DEPARTMENT OF PLANNING AND LAND USE

December 2, 2011

PROPOSED GROUNDWATER USE – HOLLENBECK CANYON WILDLIFE AREA, HONEY SPRINGS UNIT – DOG TRAINING PONDS

Figure 1 - Hollenbeck Well Location Map

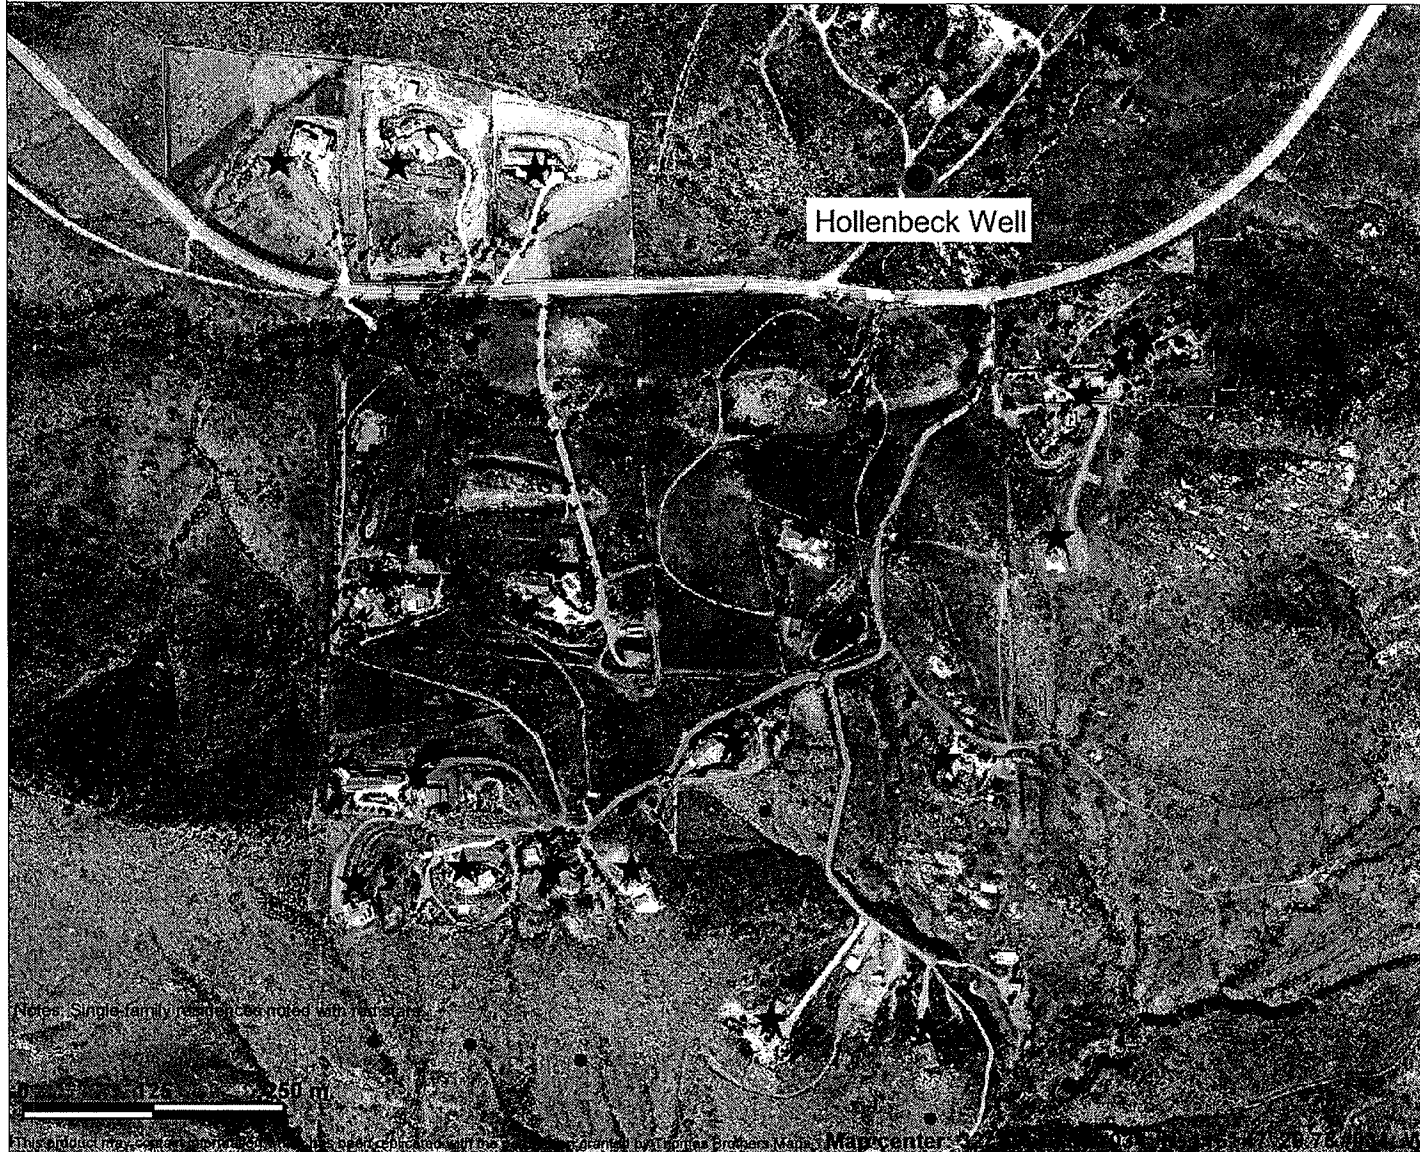
Existing Production Well: According to the 2009 report you shared with me, the project at that time was reportedly planning on obtaining its water supply from an existing well labeled as "Hollenbeck Well" on Figure 1. Unfortunately, the well completion report for this well is missing from County Department of Environmental Health files. According to information within a 2009 report your planning group provided me, the well reportedly originally produced at a rate of 800 gallons per minute when first drilled. This is more than likely an error as there has never been a well among hundreds that I have reviewed within a fractured rock aquifer that could produce at such an extraordinary rate.

As shown on Figure 2 as red stars, there are 18 single-family residences that are located within ½-mile of the existing well. It is assumed that each single-family residence has its own private well. The "Hollenbeck Well" is located approximately 460 feet from the nearest off-site residential property line.
